☐	CAT - I	APPROVED - *No Further Comments*
☑	CAT - II	APPROVED - *Subjected to Incorporation of Comments as Marked.*
☐	CAT - III	NOT APPROVED *Resubmit with Incorporation of Comments as Marked / Discussed.*
☐	CAT - IV	INVALID SUBMISSION *Due to Non-Conformity of Tender specifications / drawings*

TITLE :-
DOUBLE WALL PUF INSULATED
MOTORISED ROLLING SHUTTER

CLIENT - RINAC
PROJECT -ROLLING SHUTTER
FORMAT NO - NIHVA-DD-F-03
DWG. NO. : NIHVA/23-24/104 REV-01
SCALE: NTS WT: SHEET: 01 OF 01
ALL DIMENSION ARE IN mm
If any queries contact : design@nihva.com

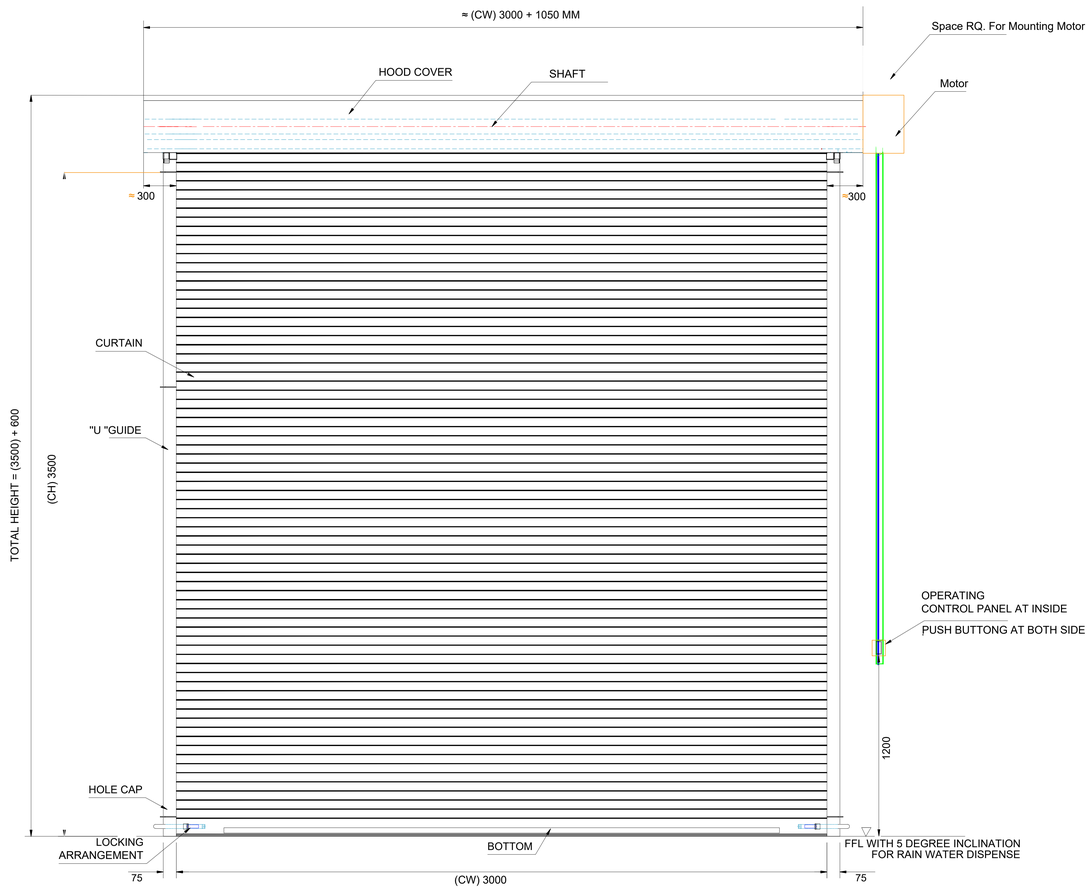
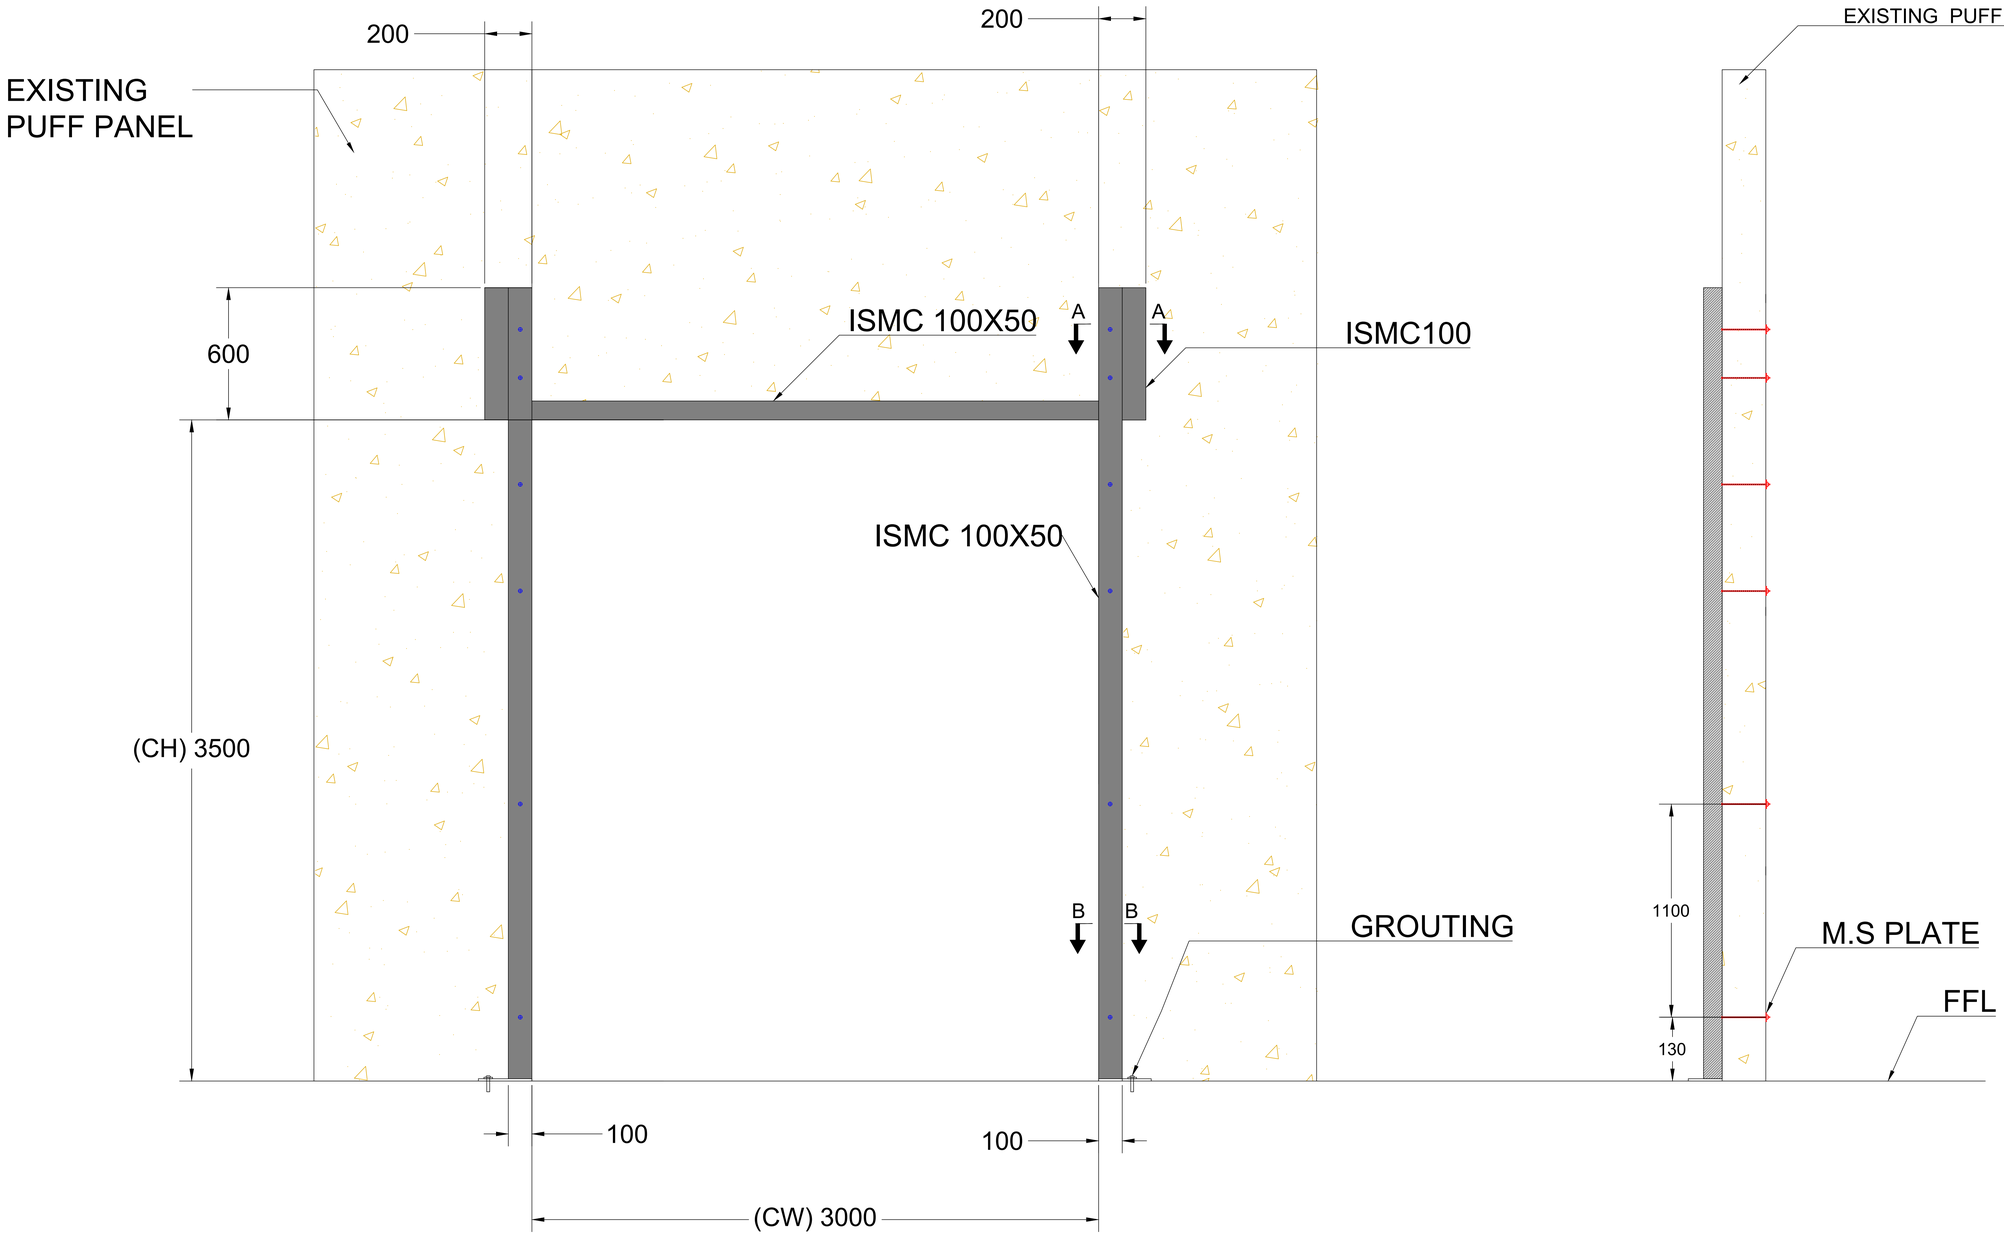
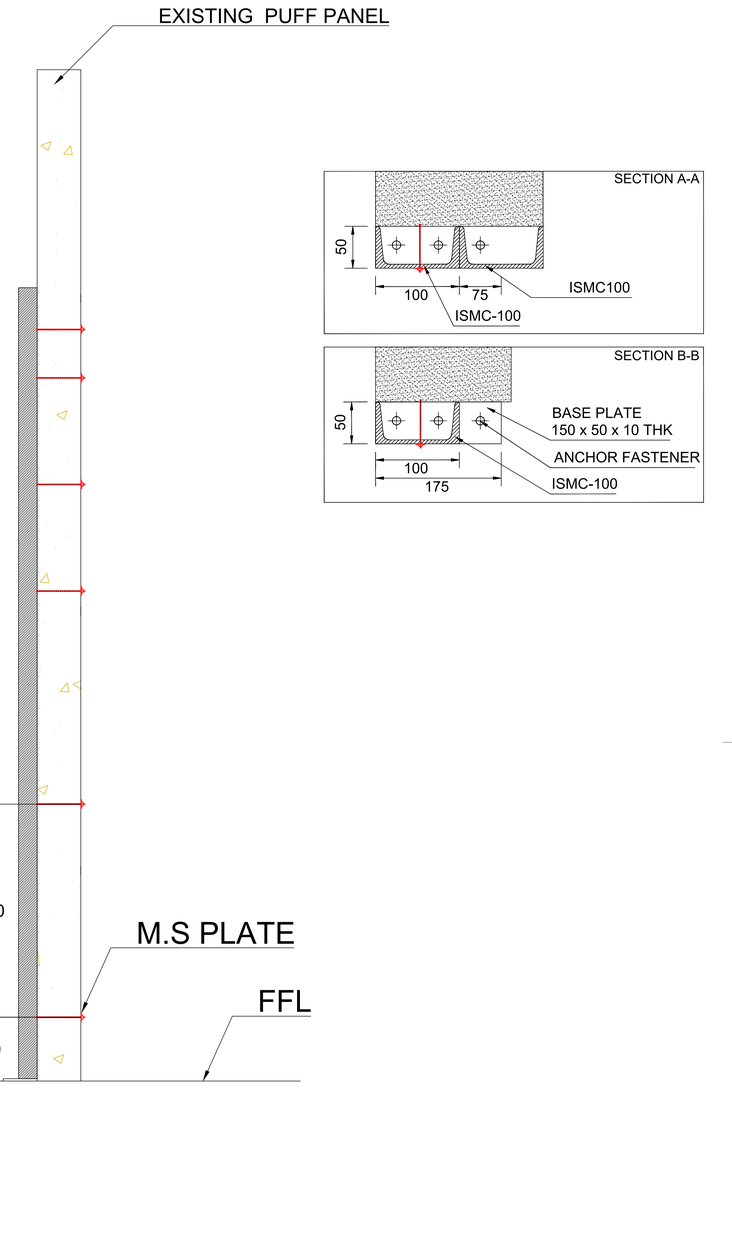
COMMON COMMENTS :-
1. CONTRACTOR NEEDS TO VERIFY THE DIMENSION OF THE OPENING ON SITE BEFORE PROCEEDING FOR EXECUTION.
2. OPENING CONDITION OF THE ROLLING SHUTTER SHOULD BE AS PER THE PLAN
3. NO DEVIATION FROM TENDER SPECIFICATION WILL BE ALLOWED.
4. COLOR OF CURTAIN, BRACKET, SHAFT,SIDE GUIDES, BOTTOM PATTI, HOOD COVER PU SPRAY PAINTED SIMILAR TO RAL 9006 OVER 1COAT OF EPOXY PRIMER

TITLE :-
MOTORISED ROLLING SHUTTER

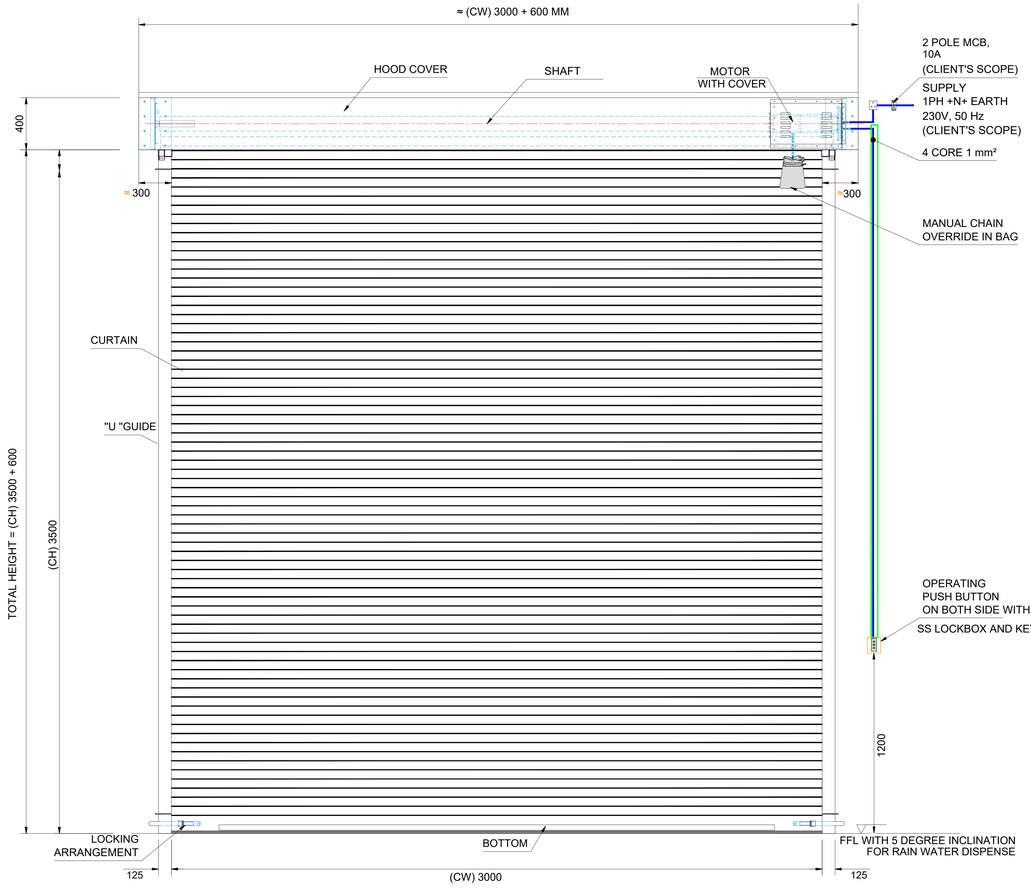
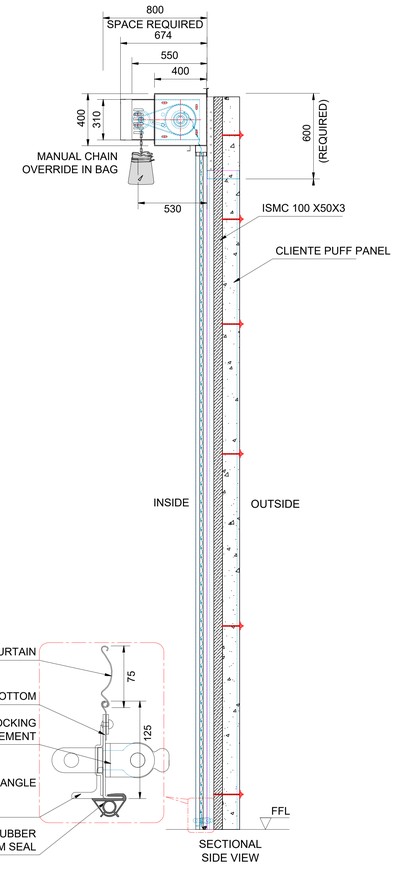
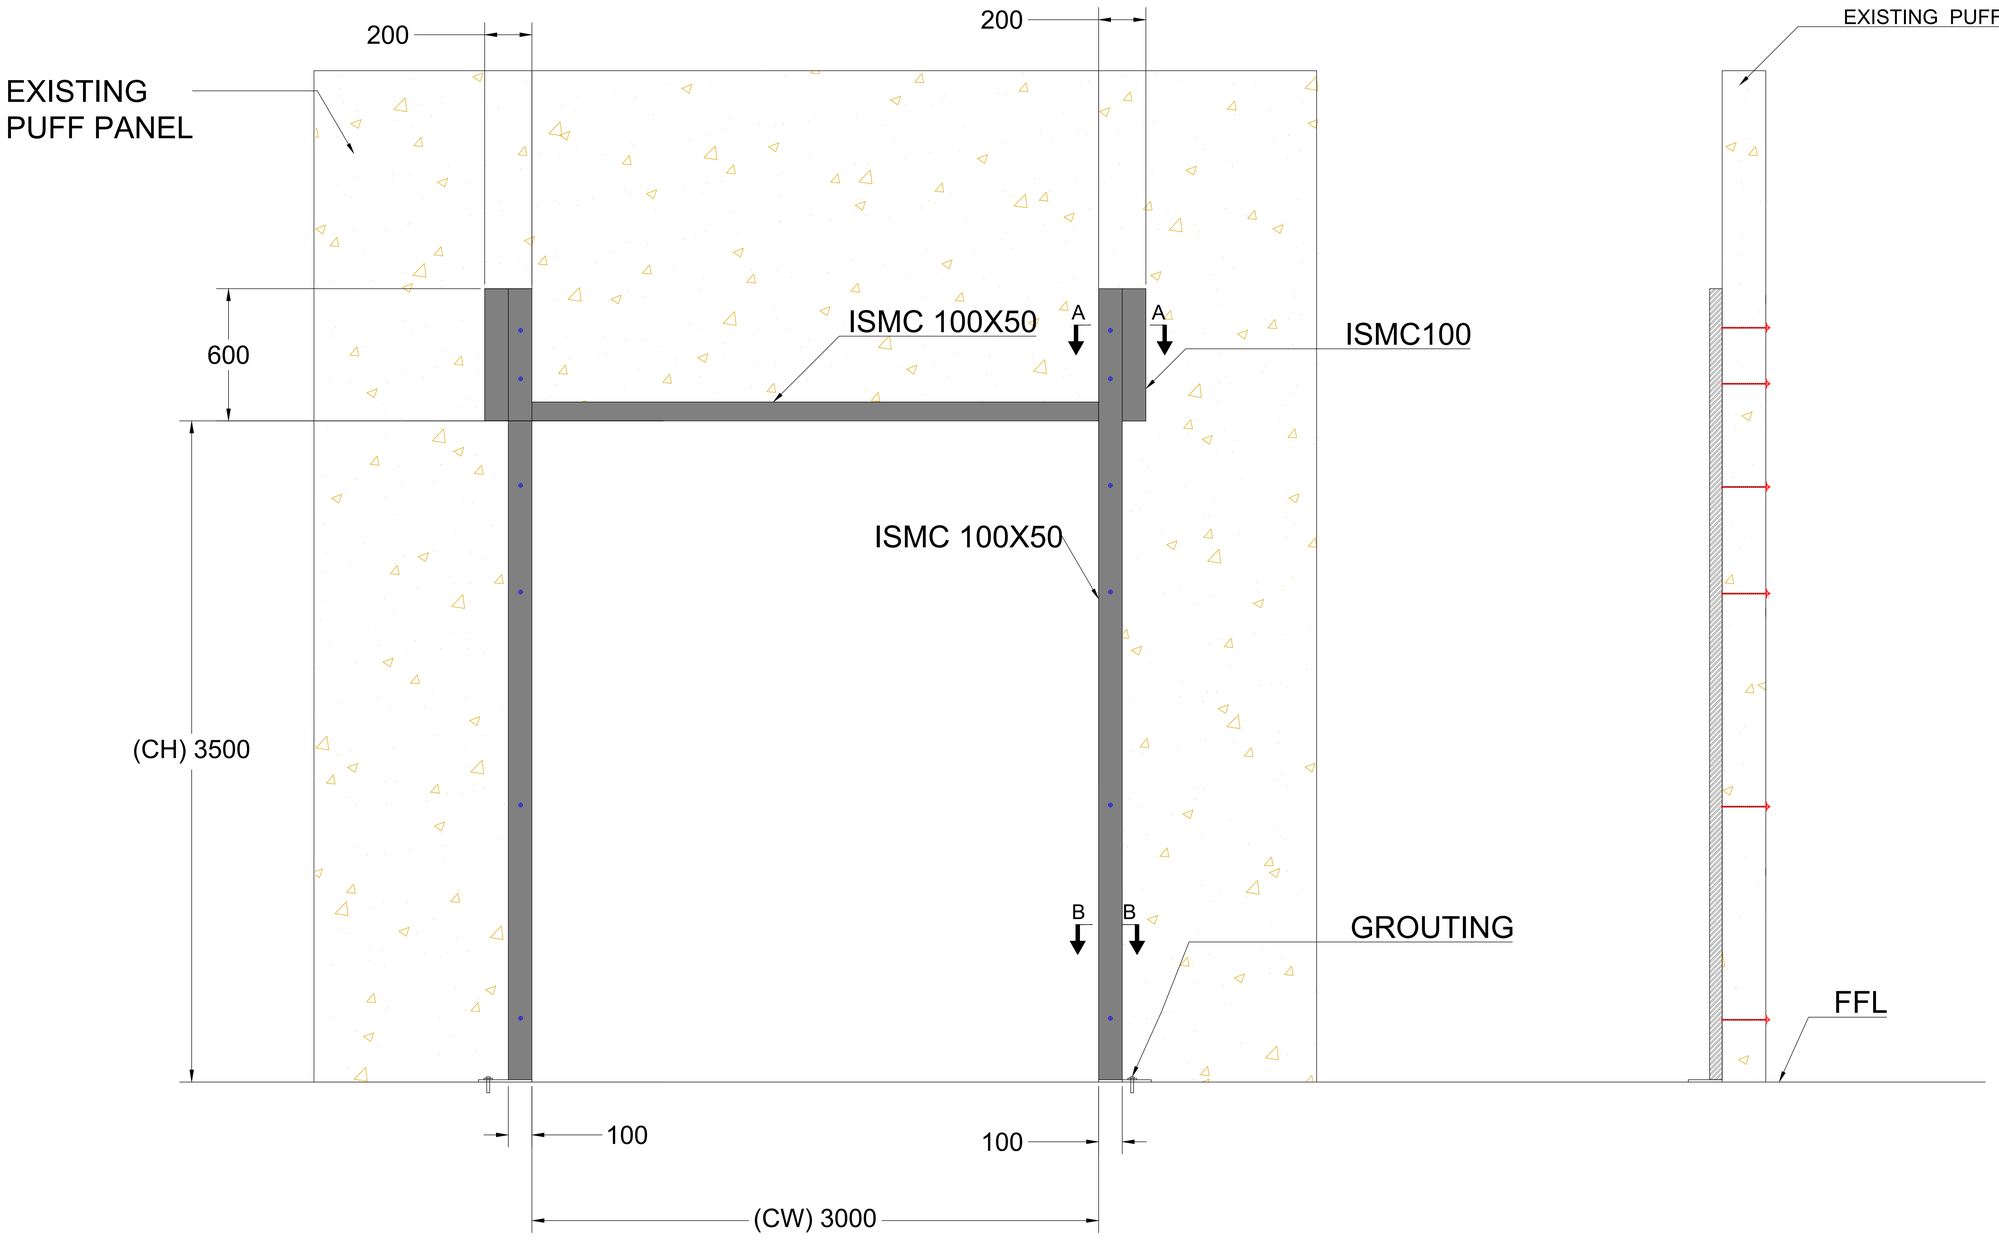
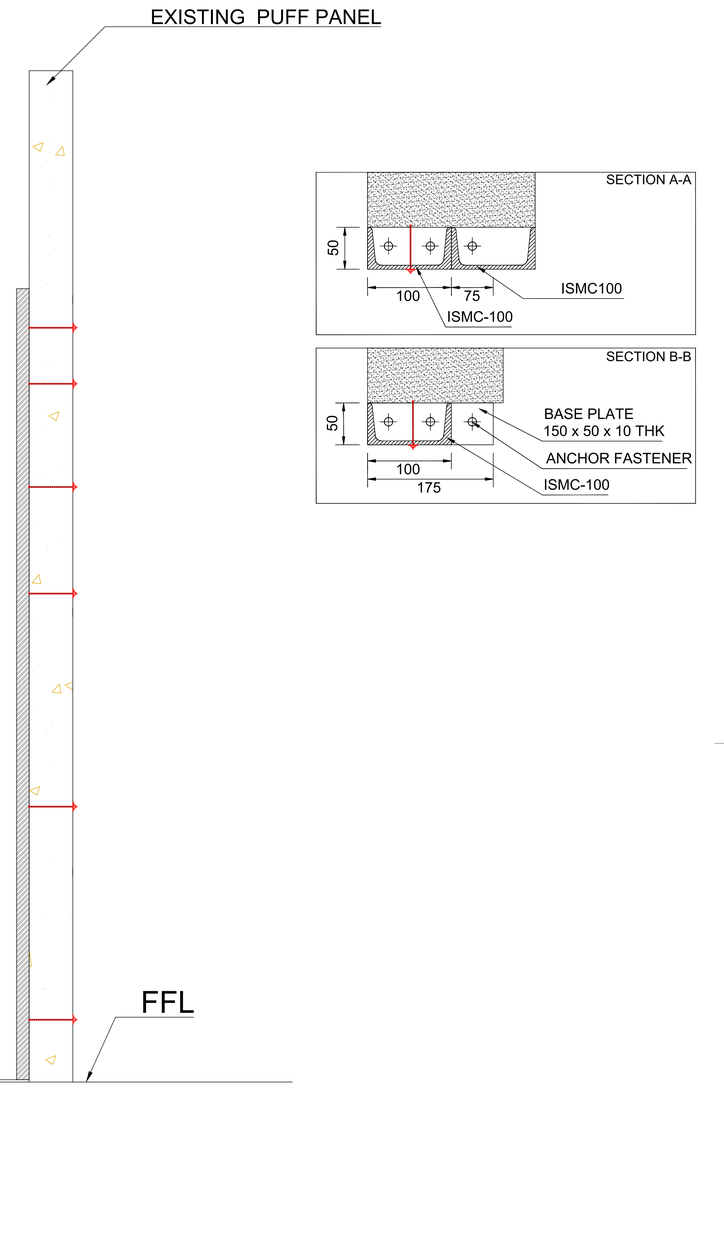
☐	CAT - I	APPROVED - *No Further Comments*
☑	CAT - II	APPROVED - *Subjected to Incorporation of Comments as Marked.*
☐	CAT - III	NOT APPROVED *Resubmit with Incorporation of Comments as Marked / Discussed.*
☐	CAT - IV	INVALID SUBMISSION *Due to Non-Conformity of Tender specifications / drawings*

COMMON COMMENTS :
1. CONTRACTOR NEEDS TO VERIFY THE DIMENSION OF THE OPENING ON SITE BEFORE PROCEEDING FOR EXECUTION
2. OPENING CONDITION OF THE ROLLING SHUTTER SHOULD BE AS PER THE PLAN
3. NO DEVIATION FROM TENDER SPECIFICATION WILL BE ALLOWED.
4. COLOR OF CURTAIN, BRACKET, SHAFT,SIDE GUIDES, BOTTOM PATTI, HOOD COVER PU SPRAY PAINTED SIMILAR TO RAL 9006 OVER 1COAT OF EPOXY PRIMER
